Service Letter No. 414

SUBJECT: Modification of Exhaust Stack, Right Side

MODELS AFFECTED: PA-24 "250" Comanches, Serial Numbers 24-103 to 24-3557 incl.

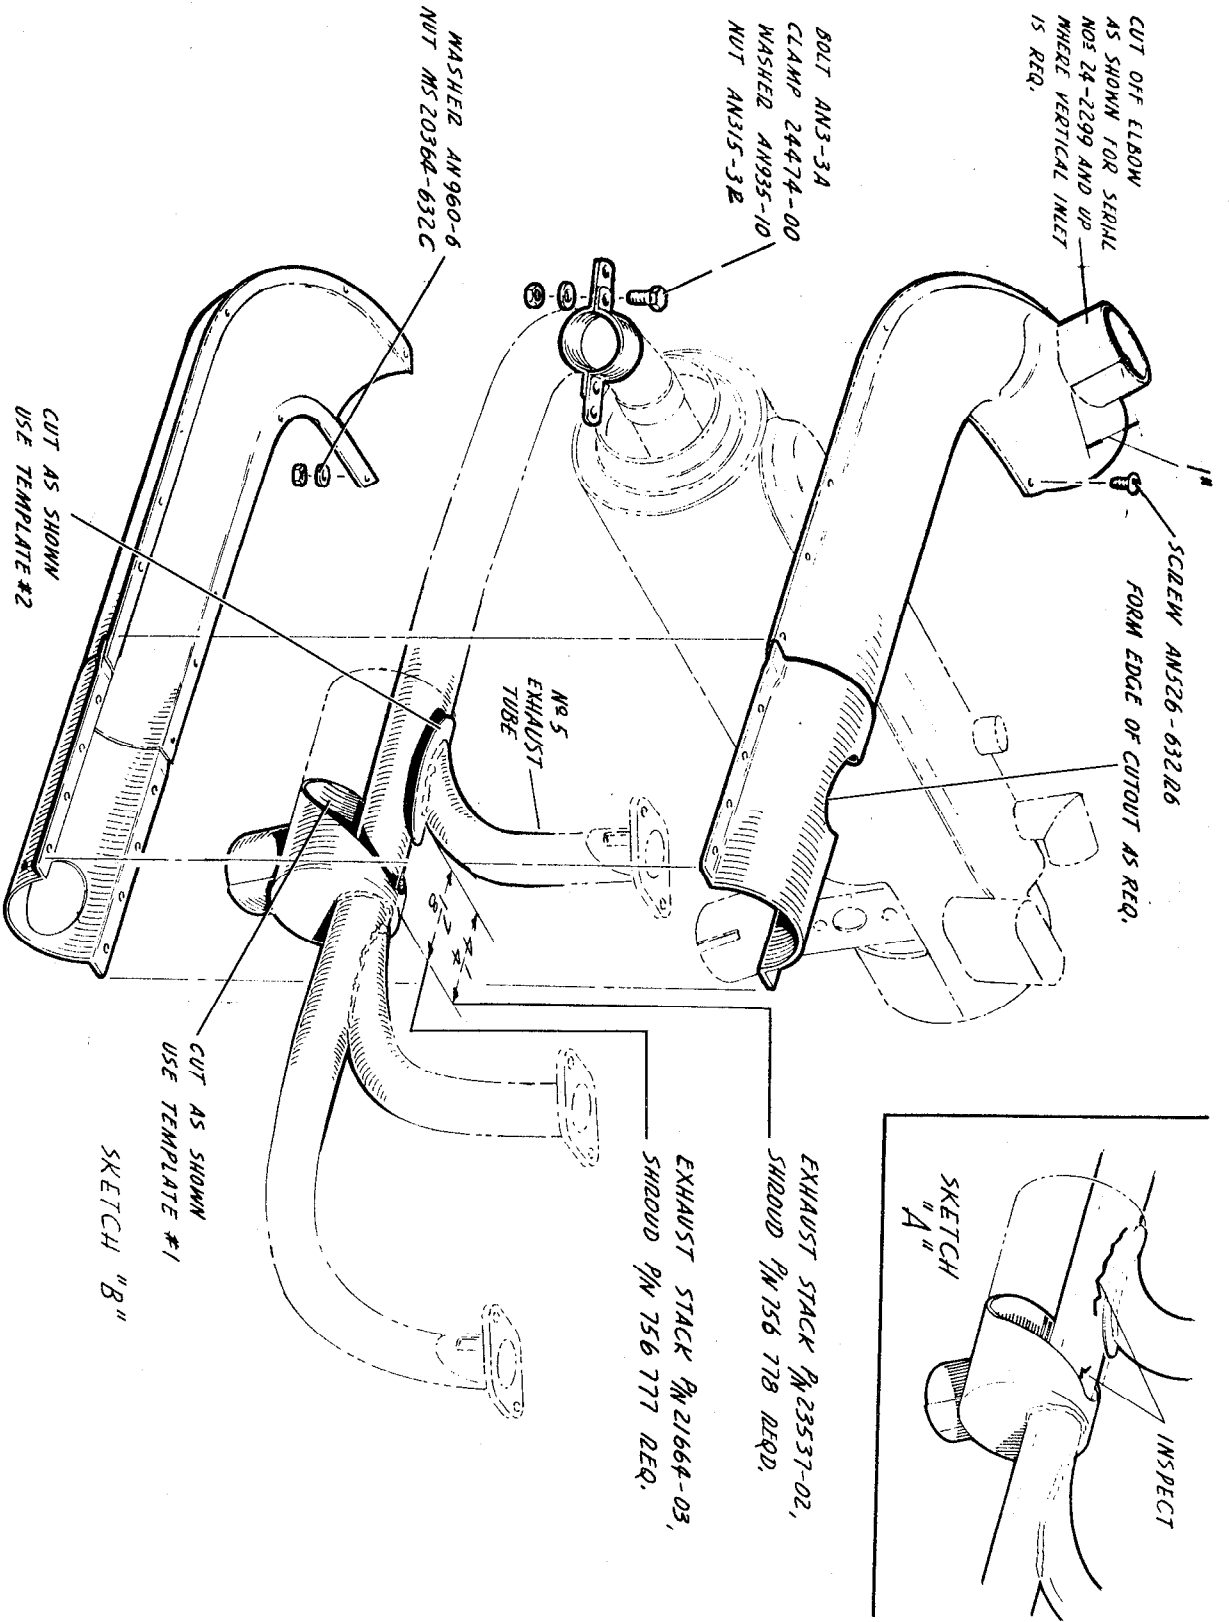
We have had reports from the field advising that cracks have been observed in the forward end of the right exhaust stack under the stainless steel shroud. These cracks have occurred only on the PA-24 "250" Comanches which are included in the group of serial numbers listed above. See Sketch "A."

Since a visual inspection of the stack under the shroud is difficult to accomplish, a modification of the stainless steel shroud has been made to permit a visual inspection of this area. This modification consists of cutting away a section of the stainless steel shroud and replacing the exhaust stack shroud assembly at the rear of the stack. See Sketch "B."

*NOTE: Providing the original exhaust stack has been replaced, to assure ordering the proper kit, the distance from the front of the stainless steel shroud and the front of the exhaust pipe to the Number 5 Cylinder must be measured. See Sketch "B." Stacks measuring 1-7/8" at the above points will require shroud kit assembly number 756 777 and stacks with a 4-1/4" dimension will require kit number 756 778.

Several types of exhaust stacks are in use on the subject aircraft and each will require the appropriate exhaust stack shroud assembly. There are, therefore, two kits available and it will be necessary to determine which kit shall be ordered when making this modification:

PART NUMBER	NOMENCLATURE	AIRCRAFT APPLICATION BY SERIAL NUMBER
*756 777	Exhaust Stack Shroud Kit	24-103 to 24-3380 inclusive
756 778	Exhaust Stack Shroud Kit	24-3381 to 24-3557 inclusive
